UNITED STATES PATENT AND TRADEMARK OFFICE

APPLICATION NO.	FILING DATE	FIRST NAMED INVENTOR	ATTORNEY DOCKET NO.	CONFIRMATION NO.
09/751,185	12/29/2000	Larry R. Fairbanks	CPS1540-203B	8520
8698	7590	01/27/2006	EXAMINER	
STANDLEY LAW GROUP LLP 495 METRO PLACE SOUTH SUITE 210 DUBLIN, OH 43017			YIP, WINNIE S	
			ART UNIT	PAPER NUMBER
			3636

Office Action Summary

FIG - 2

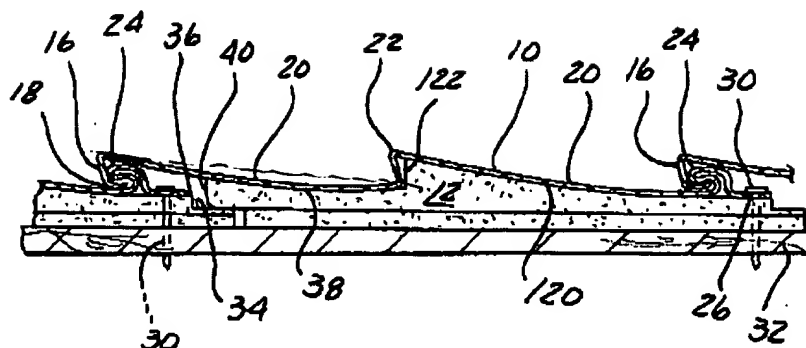
Culpepper et al. is considered to show and disclose, a vinyl siding panel comprising a facing panel (10) having at least two elongated planar portions (20) being edge-by-edge connected by a seam with a height to define a stepped contour (16) between the adjacent planar surfaces, each elongated planar portion (20) having a width extending between a first edge (22) and a second edge (16) of the planar portion, wherein each elongated planar portion (20) has a thickness about 0.035 inches (see col. 3, lines 48 or claim 16) and a width about 6 inches (or 12 inches of two planar portions) (see col. 8, line 31 or claim 17) which is in the range of "at least about 4 or 6 inches" as claimed. Culpepper et al. shows and discloses each elongated planar

portion (20) having a substantially "slight concave face" (col. 1, line 33) (see figures show bellow) formed between the first (22) and second (16) edges of the planar portions (20) for reducing or eliminating the occurrence of oil canning as the claimed invention, wherein the slight concave surface (20), in an other word, inherently has "a slight curvature" including a suitable dimension of a radius curvature, and the "slight concave surface" may include a suitable surface variance defined from the outer surface of the planar portion to an imaginary straight line (d) connected between the first (22) and second (16) edges of the planar portion due to the flexibility of the vinyl portion and the rough surface of the material. Although Culpepper et al. do not define the slight concave planar surface (20) of the sidling panel having a specific surface variance as claimed, Culpepper et al. discloses the vinyl siding having the planar portion having a thickness about 0.035 inches and a width about 6 inches substantially within the range of dimension as claimed. And, Szabo teaches a method of forming a vinyl siding comprising a forming fixture having passage to form a siding panel with a plurality of substantially planar portions each having a thickness of about 0.042 inch and a surface clearance (or surface variance) of from 0.05 to 0.075 within a range of about 0.05 includes as claimed (see col. 5. lines 1-6; lines 67-79 to col. 6, lines 1-10). Therefore, it would have been one of ordinary skill in the art, at the time the invention was made to modify a sliding panel of Culpepper et al. having the substantially planar portions being performed equally well with a slide concave surface having vary widths such as 4 or 6 inches as claimed and having a thickness to define a suitable radius curvature and having a surface variance of less than about 0.05 inches as taught by Szabo as obvious matter of engineering design choice to define the specific dimensions to achieve the same function of providing the siding panel with very desirable random shadow pattern to add

Figure 4

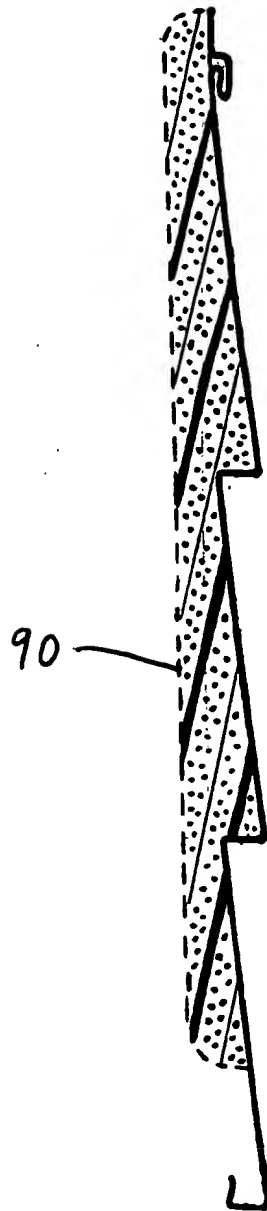
1. The disclosure is objected to because of the following informalities: the new Figure 4 (filed September 10, 2004) has not been described in the specification under sections of "Brief Description Of The Drawings" and "Detailed Description Of Exemplary Embodiment".

Appropriate correction is required.
